SERVICE PROCEDURE

22520
SEPTEMBER, 2022

SUBJECT: **SAFETY RECALL**
Tie Rod End Clamps on certain International® HV™ and HX® Series trucks built 11/18/2021 thru 08/04/2022 with feature code 02ARU, 02ARY, 02ARZ, 02ATB, 02AUR, 02AVB, 02AVC, 02AVD, or 02AVE (Meritor Steer Axle) and an additional steering axle installed by Navistar's Truck Specialty Center (TSC).

REPLACING TIE ROD END CLAMPS WITH KIT FRK-22-1002

Figure 1

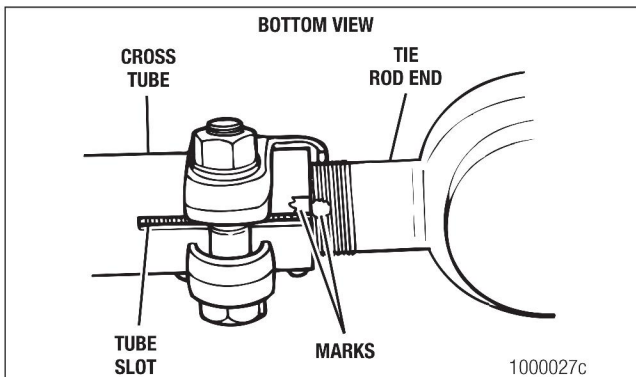
3. Use a paint pen to mark the position of both tie rod ends as shown. Be sure to mark it well so the tie rod end can be screwed back into the exact same position on the threads. Also count the amount of visible threads to confirm proper depth upon re-installation. Figure 1.

10. Thread the tie rod end back into the same position utilizing the paint pen marking. Exposed threads should match the value noted in Step 3.
11. Be sure that the clamp tab is firmly seated against the end of the cross tube. Align the clamp opening with the cross tube slot as shown in Figure 1. Tighten the clamp bolt nut to 150-175 lb-ft (203-237 Nm).

Figure 2

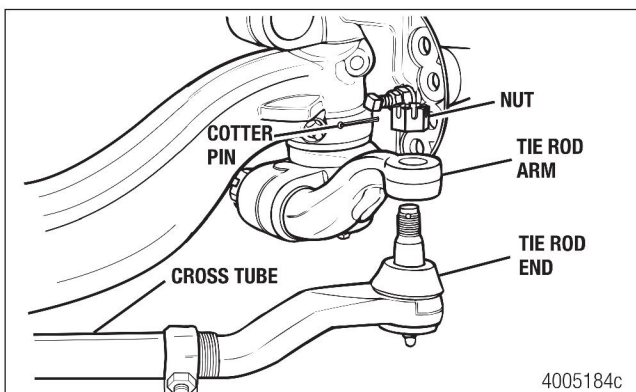
4. Remove the cotter pin and nut that fastens the tie rod end to the tie rod arm. Figure 2.

5. Disconnect the cross tube assembly from the tie rod arm. If available, use a tie rod end puller to separate the tie rod end from the tie rod arm. Figure 2. If necessary, use a leather or plastic mallet to tap on the end of the tie rod arm.
